Historic District Review Committee

Staff Report August 10, 2009

CAPP 2009-0010: Chambers/O'Brien Residence: Replace Fence in the Aldie Historic District (deferred from July 13 meeting). MCPI 396-10-1512.

Photo 1: Rear yard fence at 39338 John Mosby Highway. Sections of this fence shown on the plans to be 4' tall were approved by the HDRC in 2008. This fence ranges in height from approximately 4.5' to 5.6', with the taller sections near the rear of the lot. It has 1" spaces between the pales.

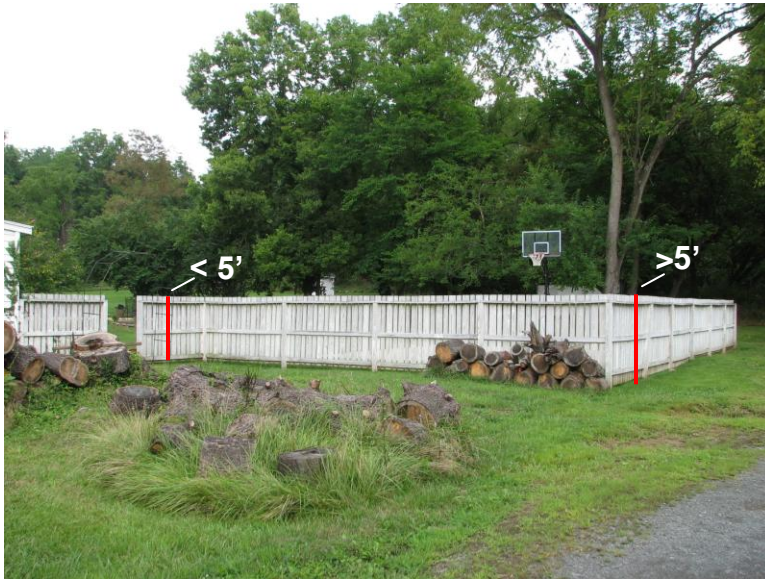
The recipient of CAPP 1984-0003 also owns 39338 John Mosby Highway, the property adjacent to the east side of the subject property. The same style of fence approved for and built at 39313 John Mosby Highway has been installed on this property. A section of the fence was approved by the HDRC as part of CAPP 2008-0006. The dimensions are similar to the fence across the street; however, the plans show that this fence is 4' tall. As built, the entire fence has an approximate average height of 5' from the top of the fence to the ground and has a 1" space between the pales. To maintain a uniform height along the top of the fence, the fence is shorter than 5' in some places and taller

than 5' in others because of topography (Photo 1). The taller sections are near the rear of the yard, the shorter sections closer to the front.
